APPROVED DRAWINGS HAVE BEEN RED LINED INDICATING A CHANGE TO MEET THE OBC. PLEASE REVIEW ALL PAGES TO ENSURE YOU ARE PROPERLY INFORMED OF CHANGES.

Tice River Homes Legacy

**TOWNSHIP OF NORTH DUMFRIES
BUILDING DEPARTMENT**

These Plans have been examined for Compliance with the Ontario Building Code requirements. A Building Permit has been issued, subject to any changes noted, under the condition that the building will be constructed in accordance with the code.

FRONT ELEVATION 'A'

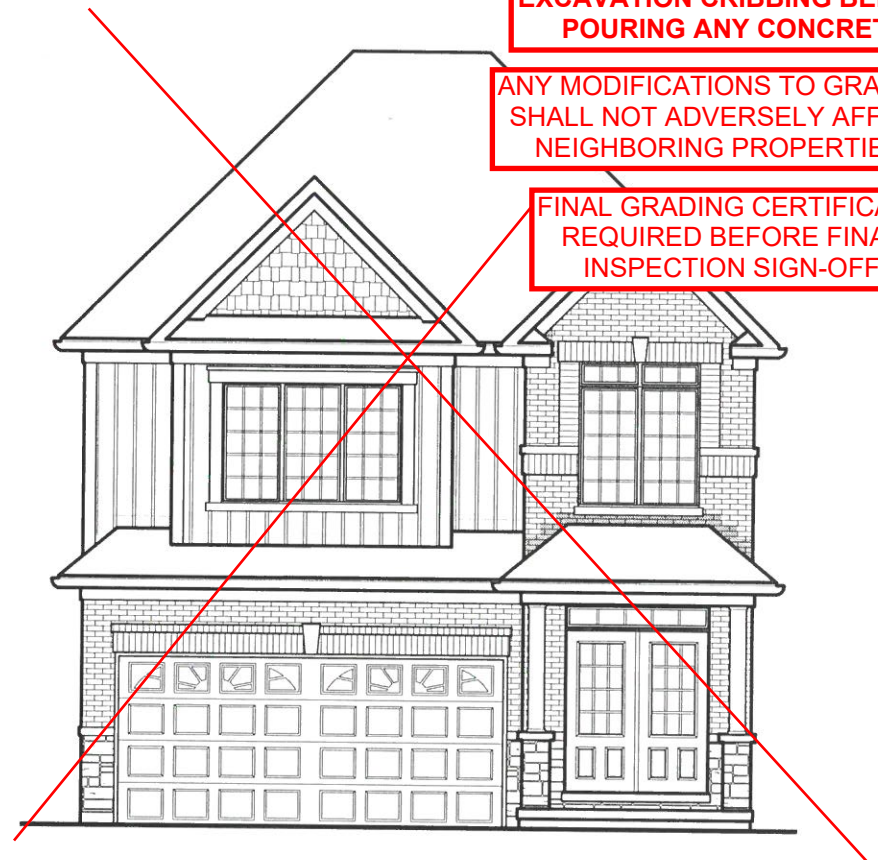
CALL FOR INSPECTION OF EXCAVATION CRIBBING BEFORE POURING ANY CONCRETE

ANY MODIFICATIONS TO GRADING SHALL NOT ADVERSELY AFFECT NEIGHBORING PROPERTIES.

FINAL GRADING CERTIFICATE REQUIRED BEFORE FINAL INSPECTION SIGN-OFF

BASEMENT PLAN ELEV. 'A' & 'B'

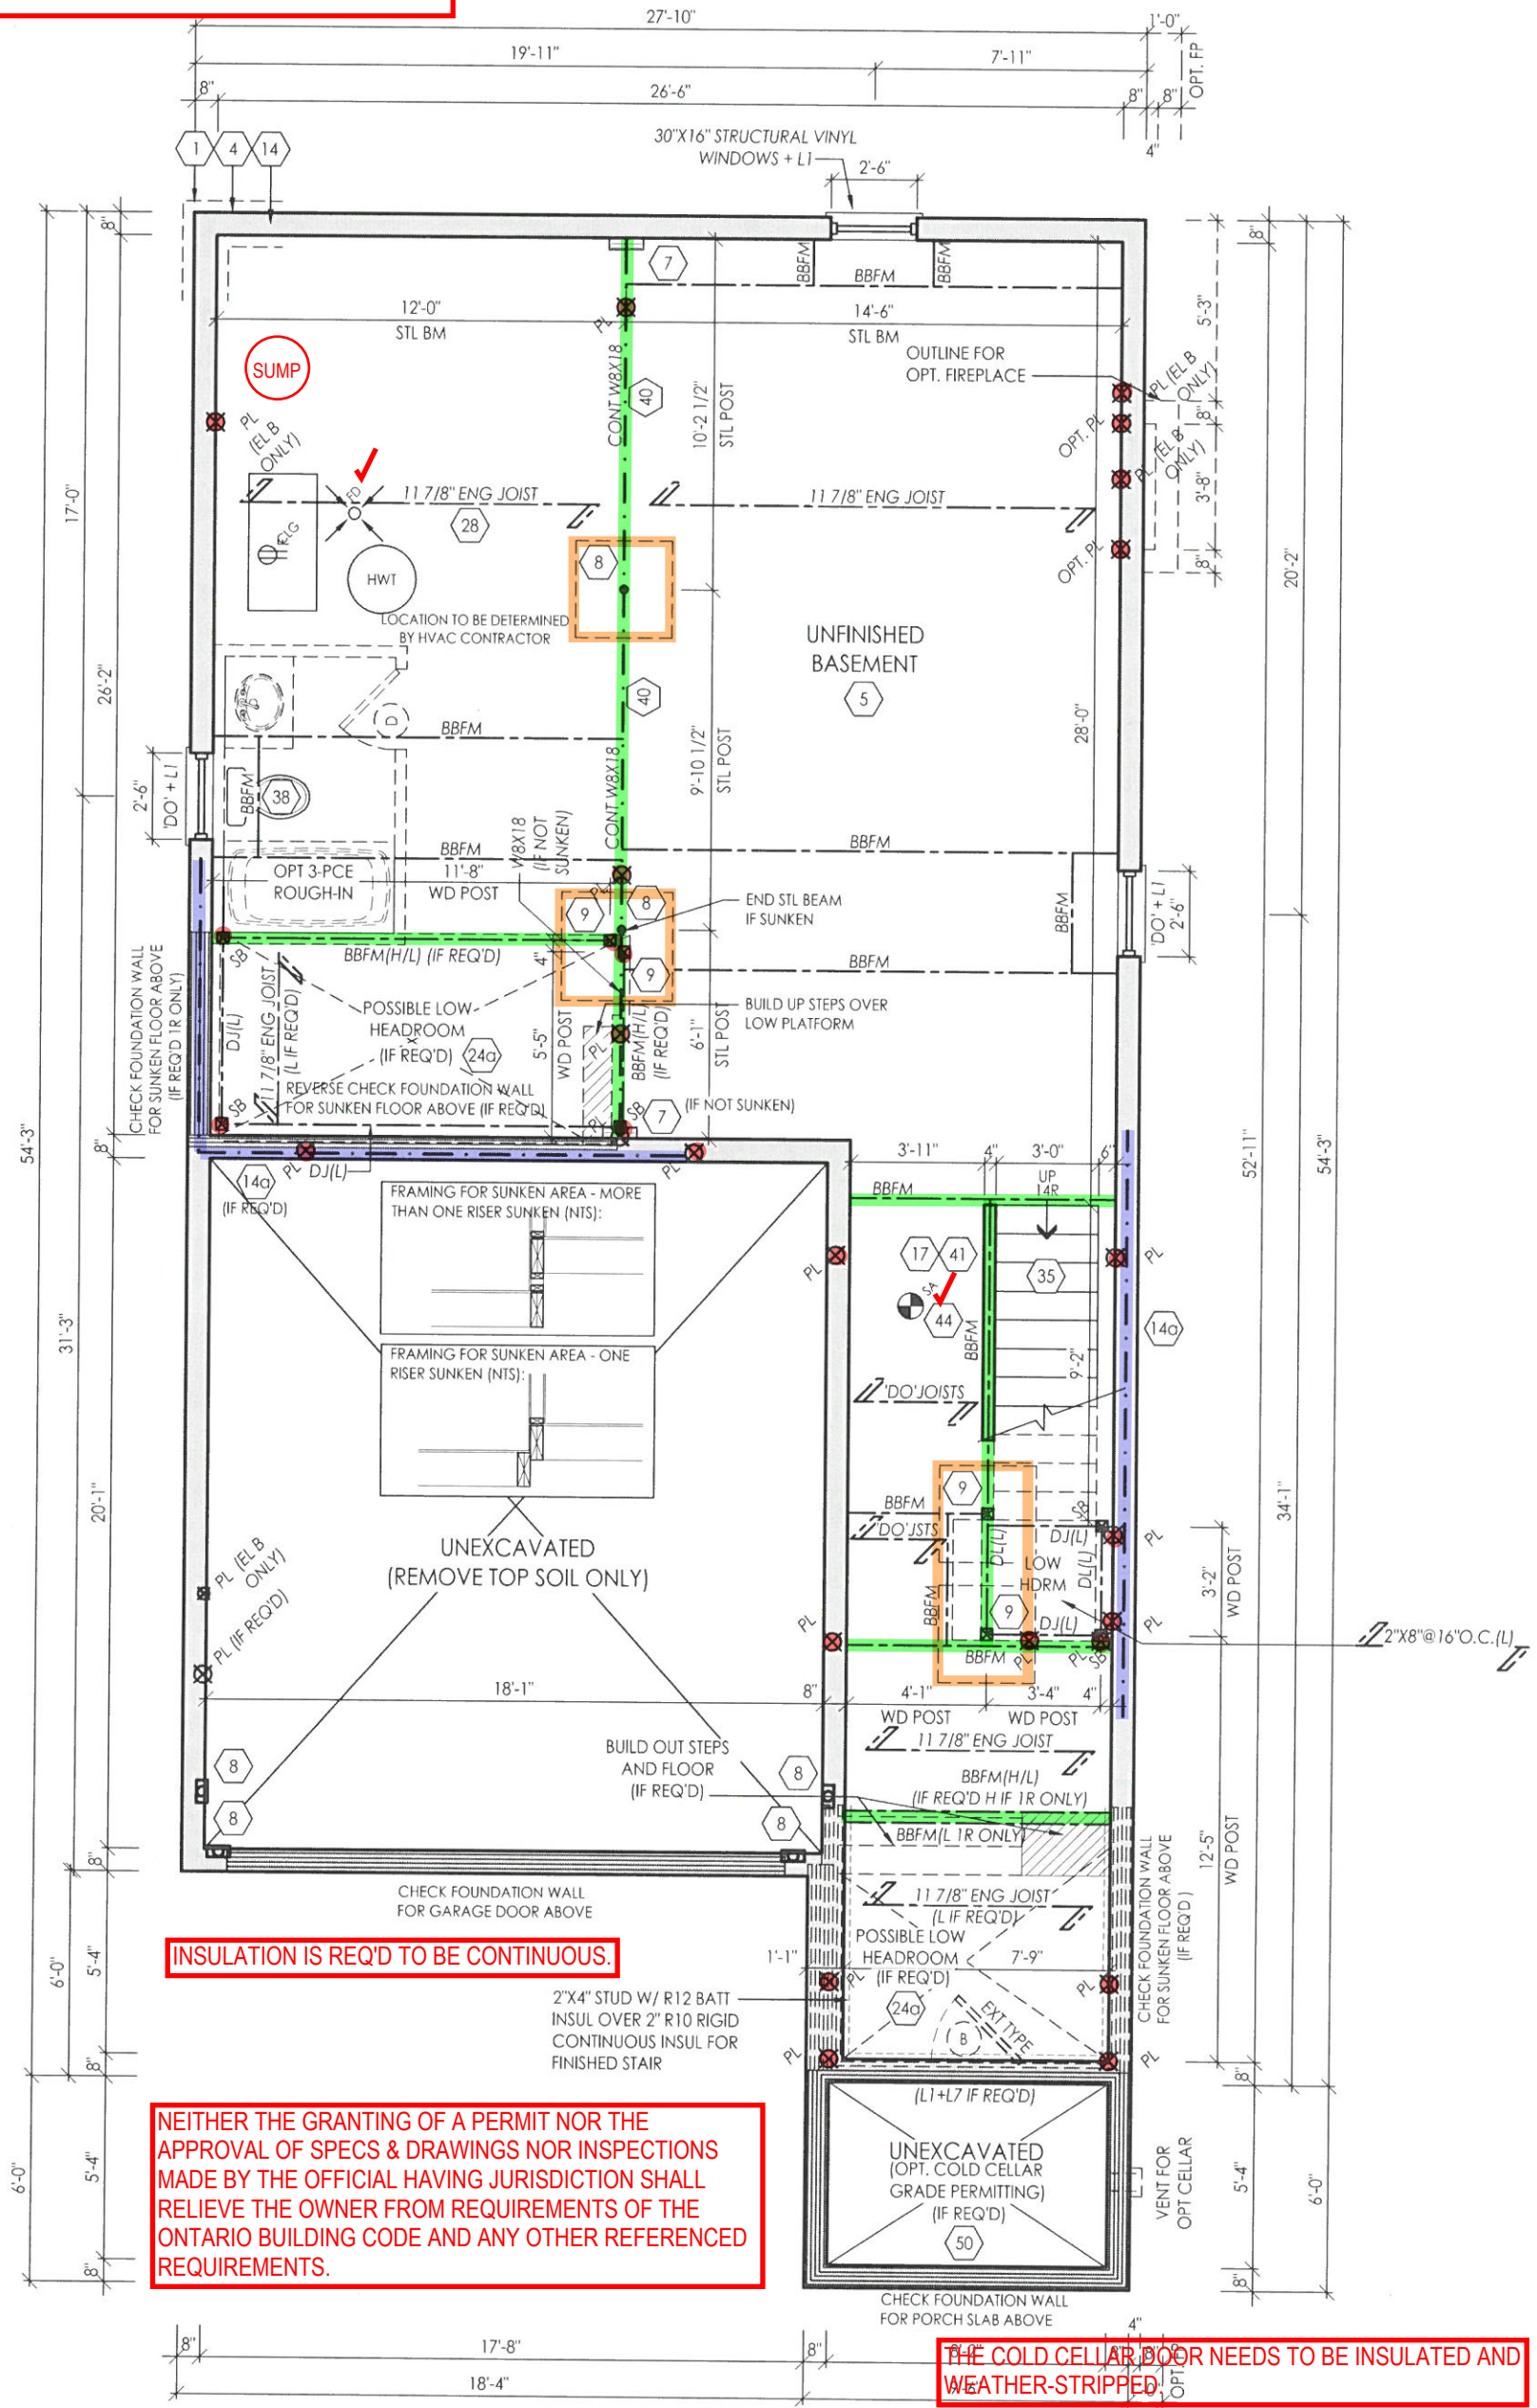
A SEPARATE BUILDING PERMIT WILL BE REQUIRED TO FINISH THE BASEMENT.

INSULATION IS REQ'D TO BE CONTINUOUS.

THE COLD CELLAR DOOR NEEDS TO BE INSULATED AND WEATHER-STRIPPED

SECOND FLOOR ELEV. 'A'

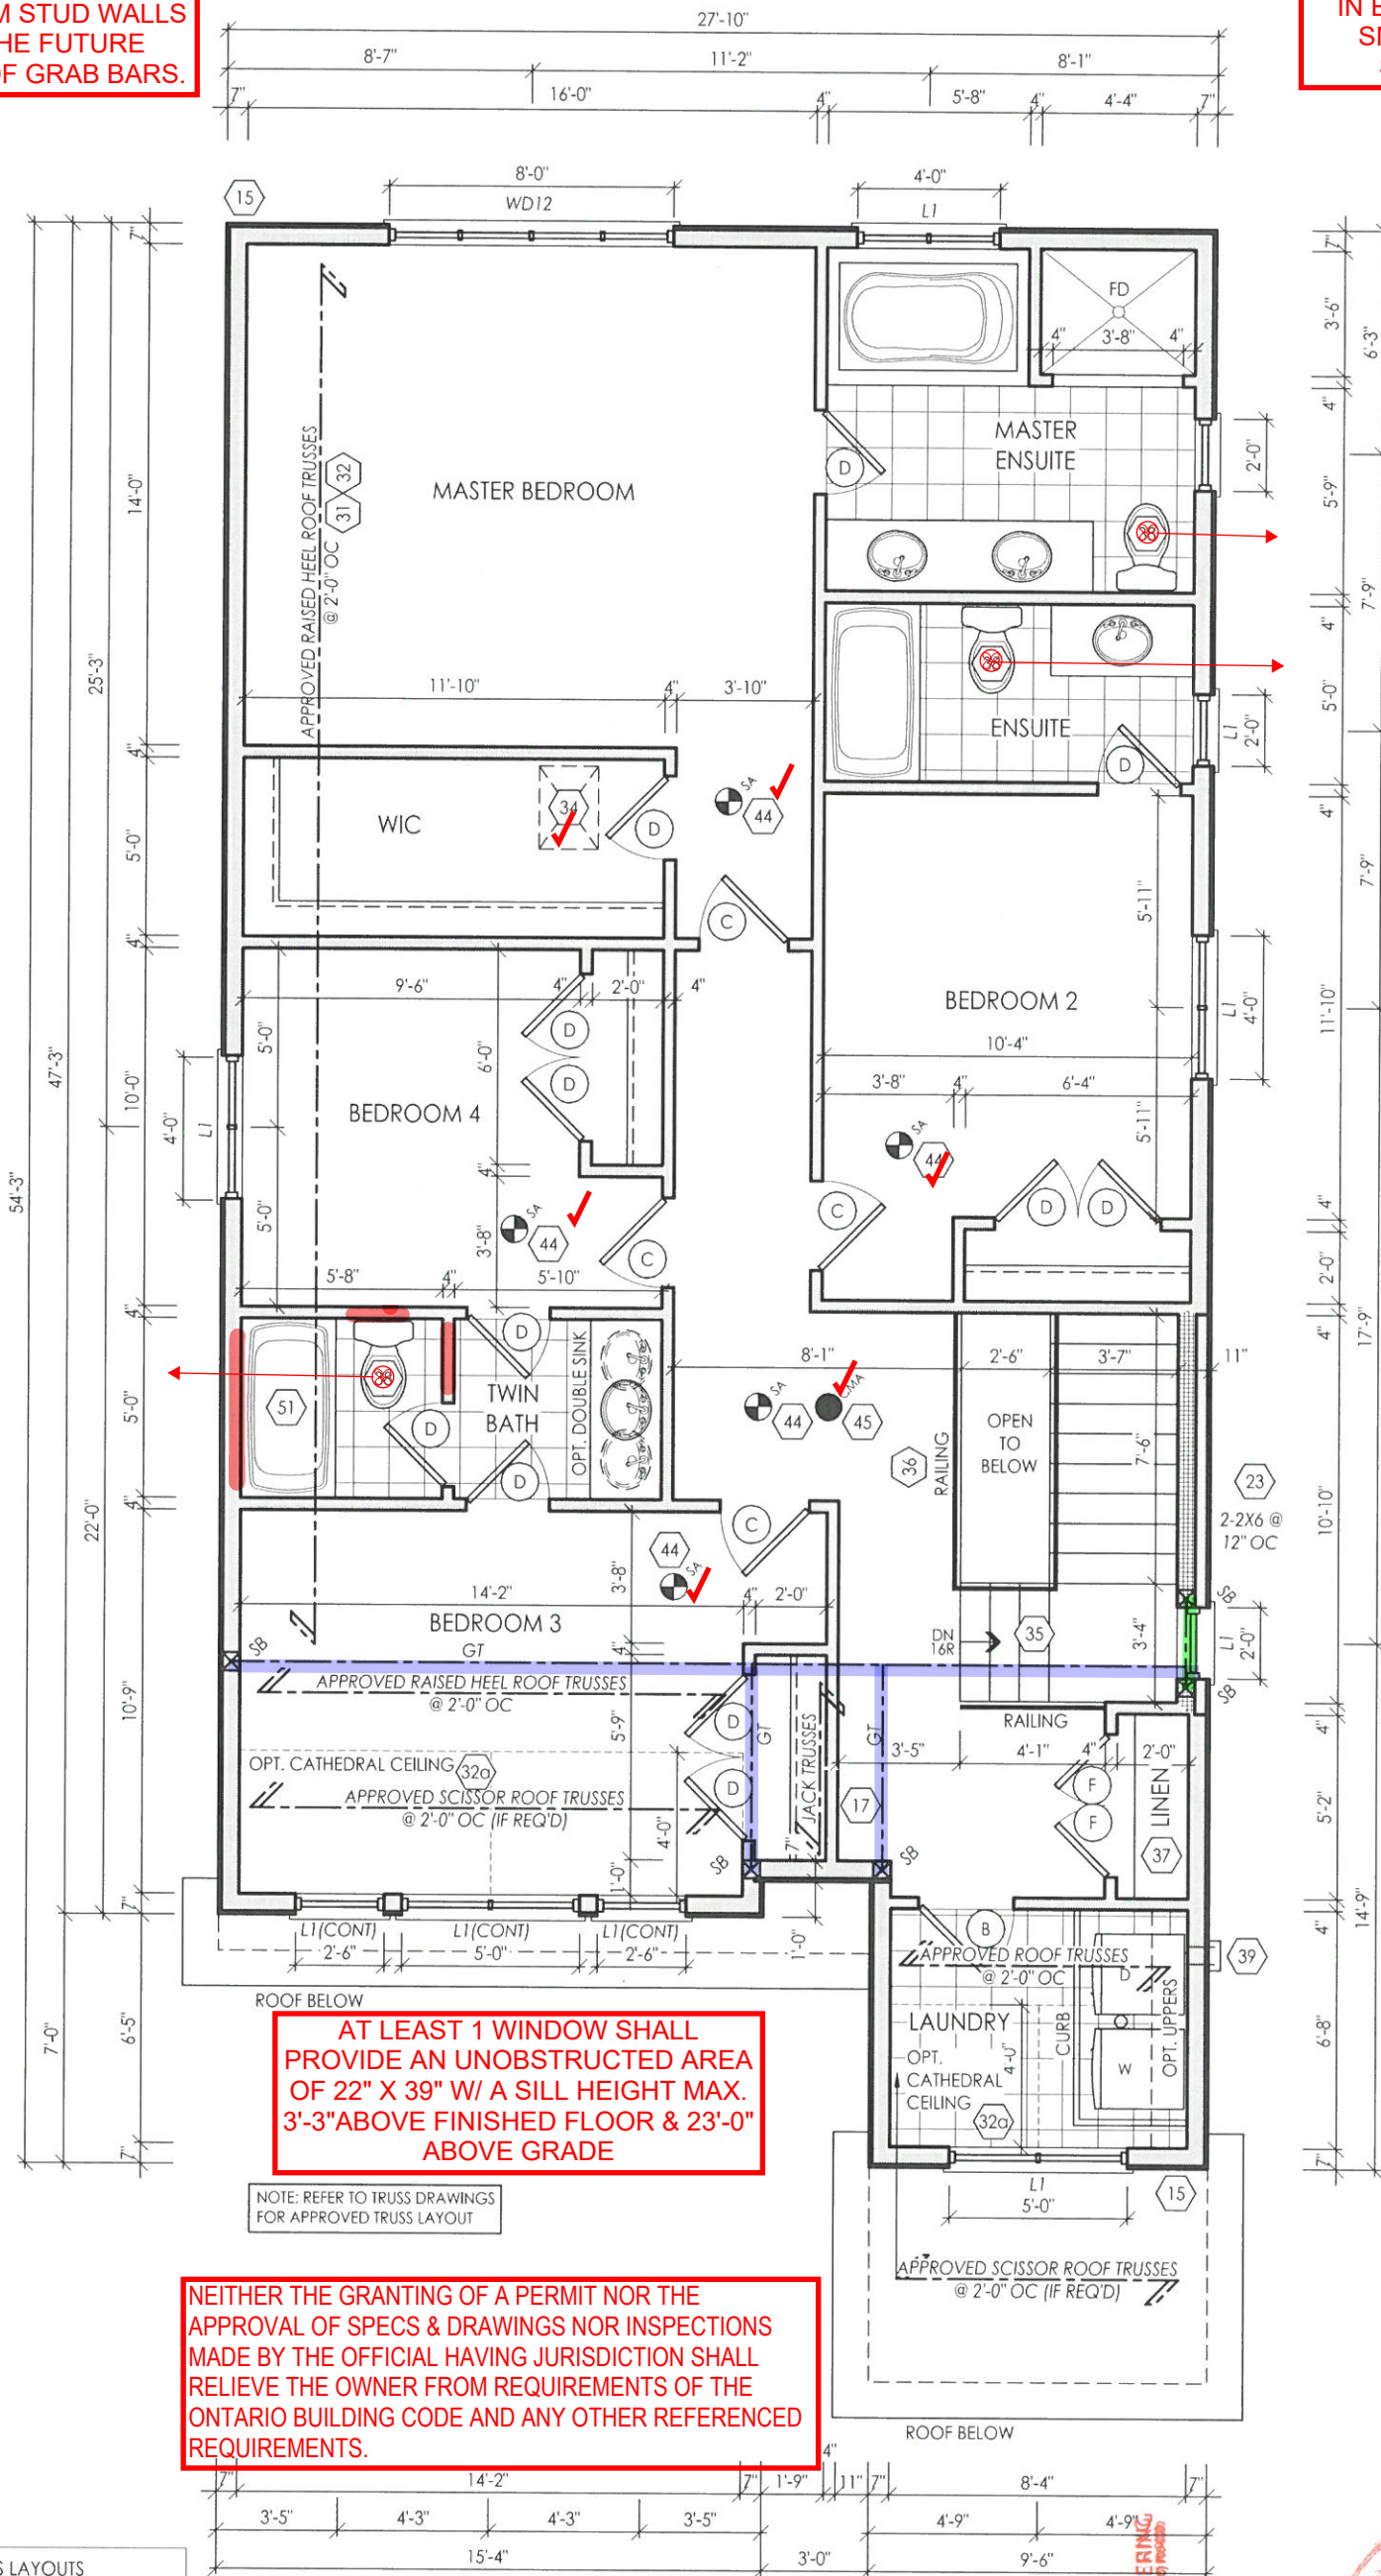
REINFORCEMENT REQUIRED IN MAIN BATHROOM STUD WALLS TO PERMIT THE FUTURE INSTALLATION OF GRAB BARS.

SMOKE ALARMS WITH VISUAL ALARM ARE REQUIRED ON EACH FLOOR AND IN EACH BEDROOM INCLUDING A SMOKE/CO IN THE HALL THAT SERVICES THE BEDROOM.

AT LEAST 1 WINDOW SHALL PROVIDE AN UNOBSTRUCTED AREA OF 22" X 39" W/ A SILL HEIGHT MAX. 3'-3" ABOVE FINISHED FLOOR & 23'-0" ABOVE GRADE

REAR ELEVATION 'A' & 'B'

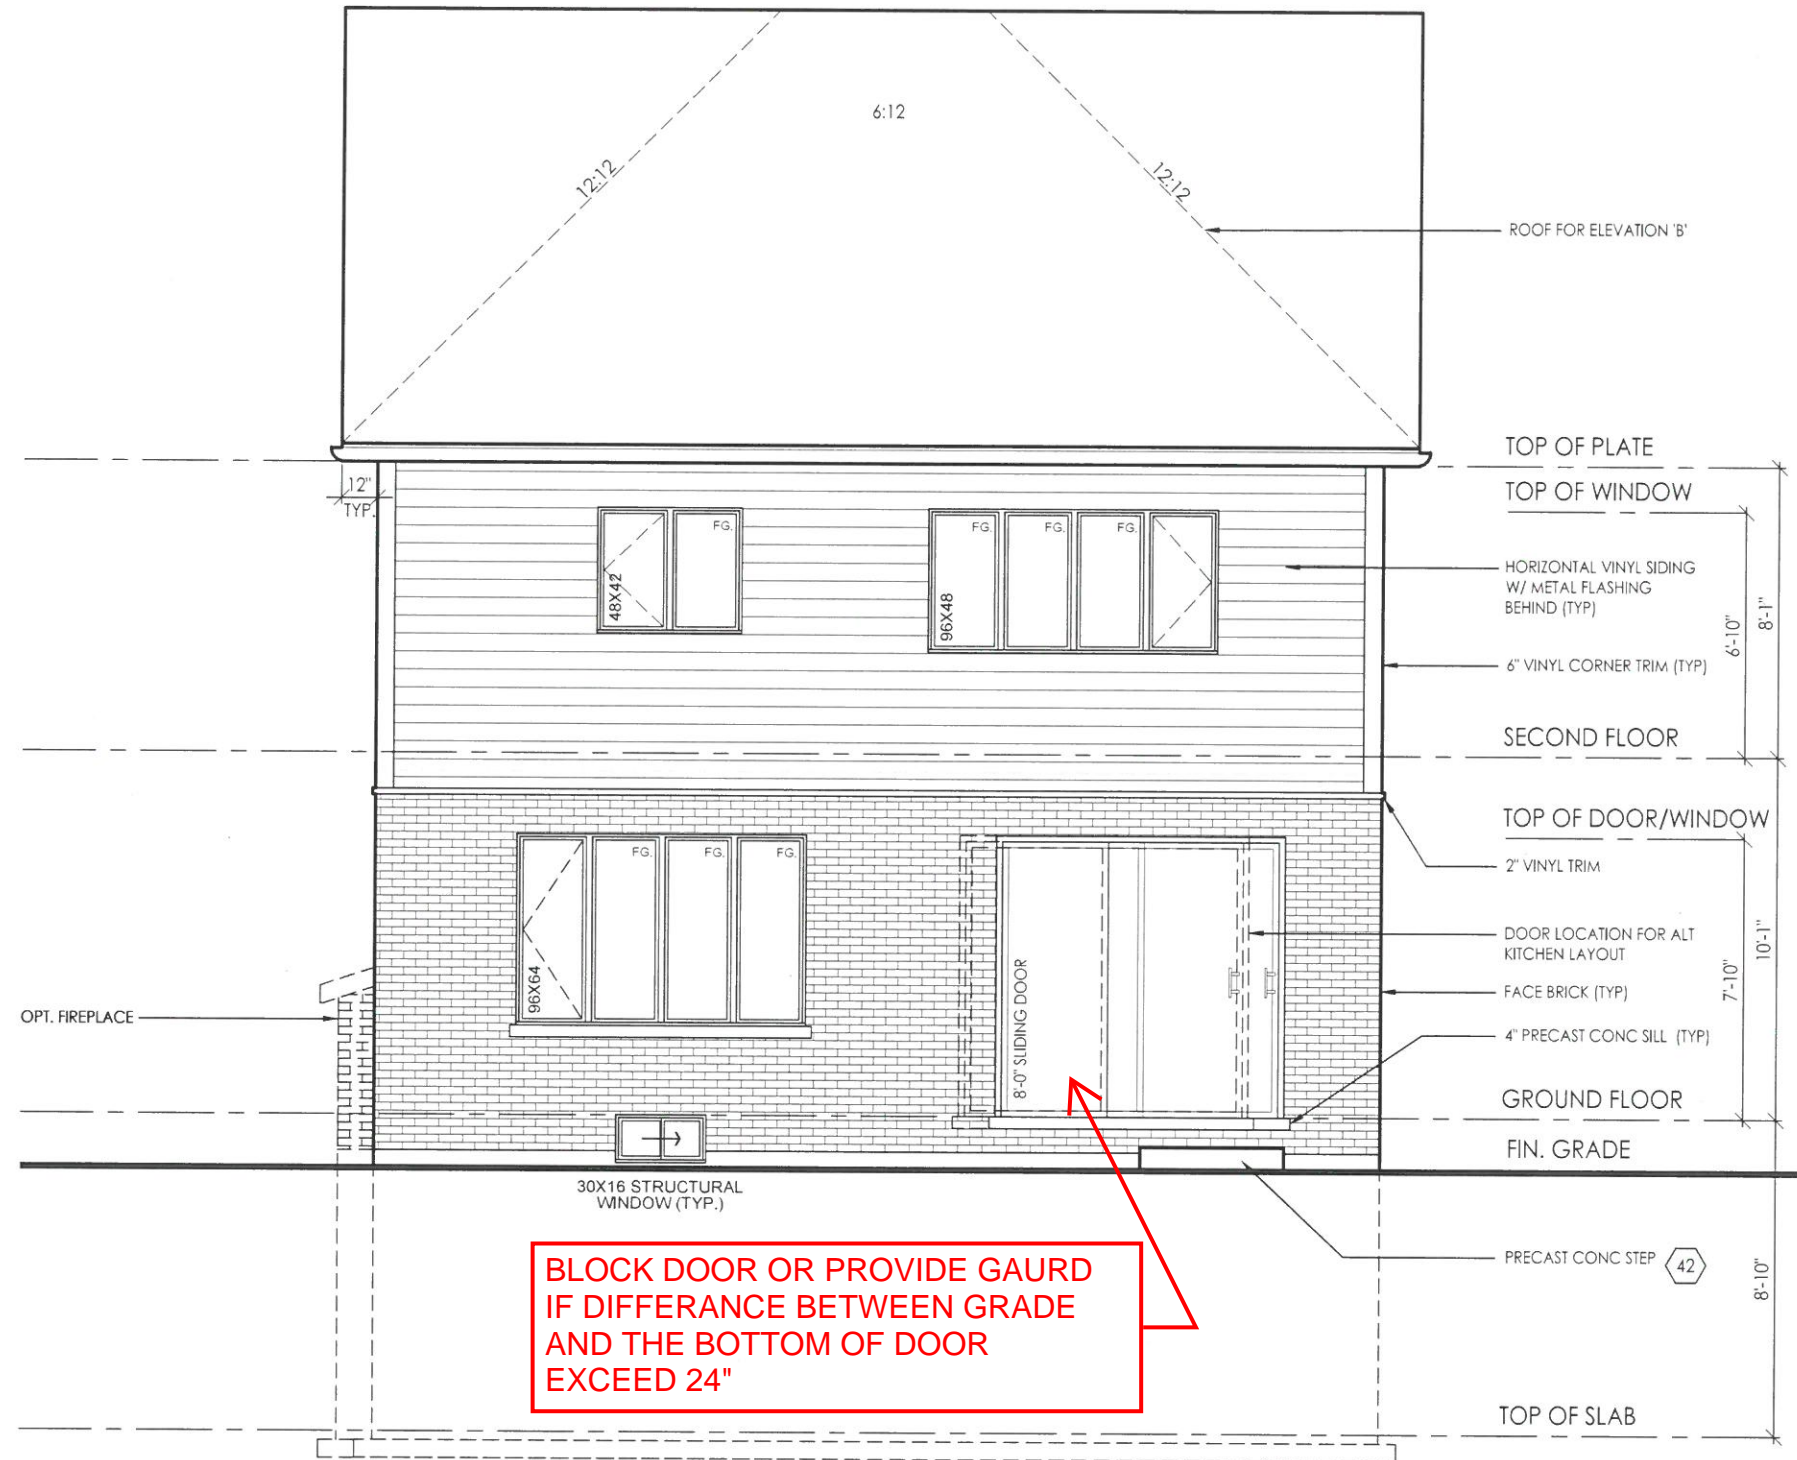
**BLOCK DOOR OR PROVIDE GAURD
IF DIFFERENCE BETWEEN GRADE
AND THE BOTTOM OF DOOR
EXCEED 24"**
